# Product Change Notification

Issue Date: 12-Apr-2021

Changing Production	All Encoders, Rotary Potentiometers and Position Sensors				
Changing Part Number	Checking TABLE (See next Page)				
Changing Point	<p>Plating change of Steel Plate witch is used as Mounting Metals and Covers.                      &lt;Parts Example&gt;</p>  <p>&lt;Detail of Changing Point&gt;                      ・Plating Change of Steel Plate</p> <table border="1" data-bbox="646 1171 1356 1234"> <tr> <td>CURRENT</td> <td>NEW</td> </tr> <tr> <td>Zn-Sn-Ni</td> <td>Zn</td> </tr> </table>	CURRENT	NEW	Zn-Sn-Ni	Zn
CURRENT	NEW				
Zn-Sn-Ni	Zn				
Changing Reason	Current Supplier of Steel Plate decided to stop production of Zn-Sn-Ni Plating one. As Alternative, Zn Plating is chosen because of same performance.				
Changing Request Plan	From Jan.2023				
Customer Feedback	Please feedback your agreement of changing process transition until end of May.2021				
Note	* 1st shipment after changing will be informed to each customer with order number and packing sign in advance.

## <Test Condition>

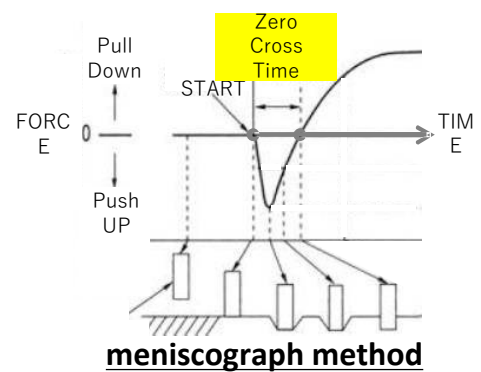
Solder Temp: 255±2°C

Dipping Speed: 5mm/s

Dipping Depth: 3mm

Zero Cross Time: 3s max.

Plating	Zero Cross Time[S]	Judgment [Spec: 3s max]
①	Current (Zn-Sn-Ni)	2.2~2.6	PASS
②	NEW (Zn)	1.6~2.0	PASS

The NEW Plating has better Zero Cross Time than current one for Solder Wettability Test
